Proposal for Supplement 5 to the 02 series of amendments to UN Regulation No. 129

Submitted by the expert from Spain

The text reproduced below was prepared by the expert from Spain on behalf of the Technical Services Group (TSG) on UN Regulation No. 129. The modifications to the current text of Regulation are marked in bold for new or strikethrough for deleted characters.

Annex 2., amend to read:

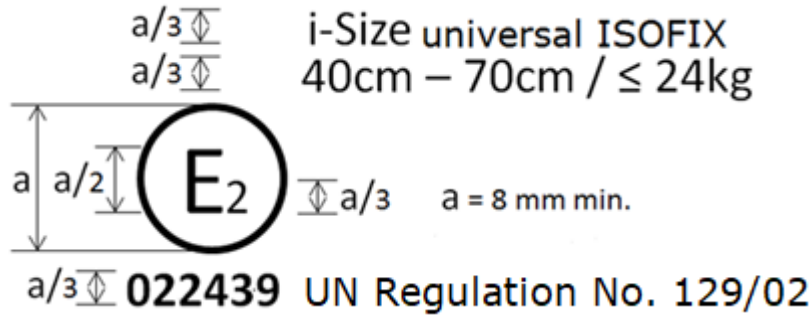
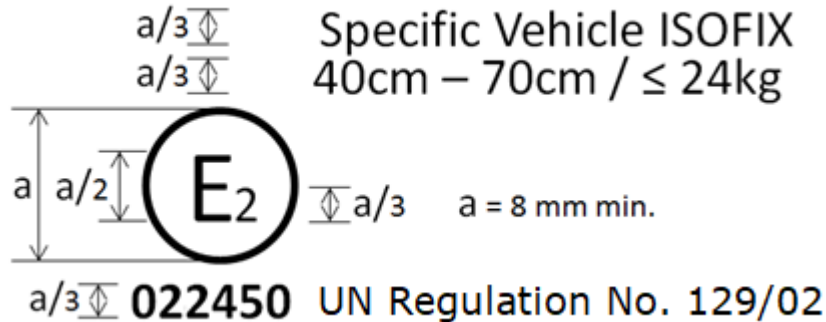
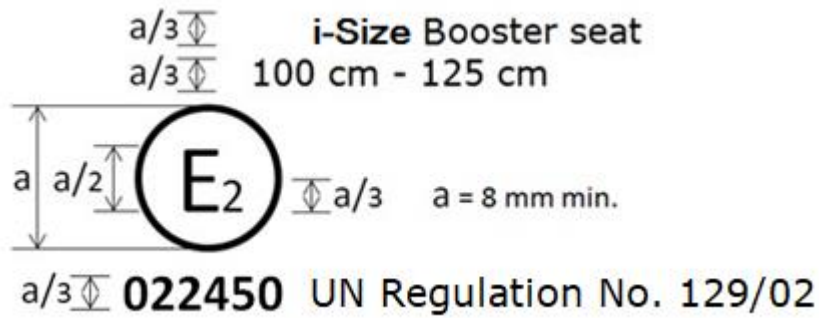
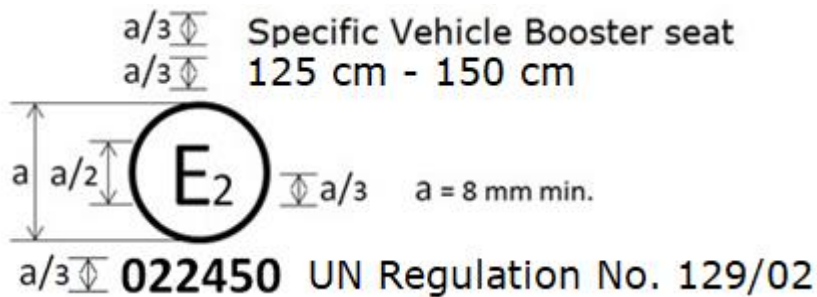
The Enhanced Child Restraint System bearing the above approval mark...125 cm - 150 cm size range...

1. Dimension of the approval number is currently not specified
2. Correct wording for regulation used. UN Regulation No. 129/02 instead of Regulation No. 129/02
3. Changed the 145 cm stature of the Specific Vehicle Booster seat to 150 cm stature as this is the upper limit.
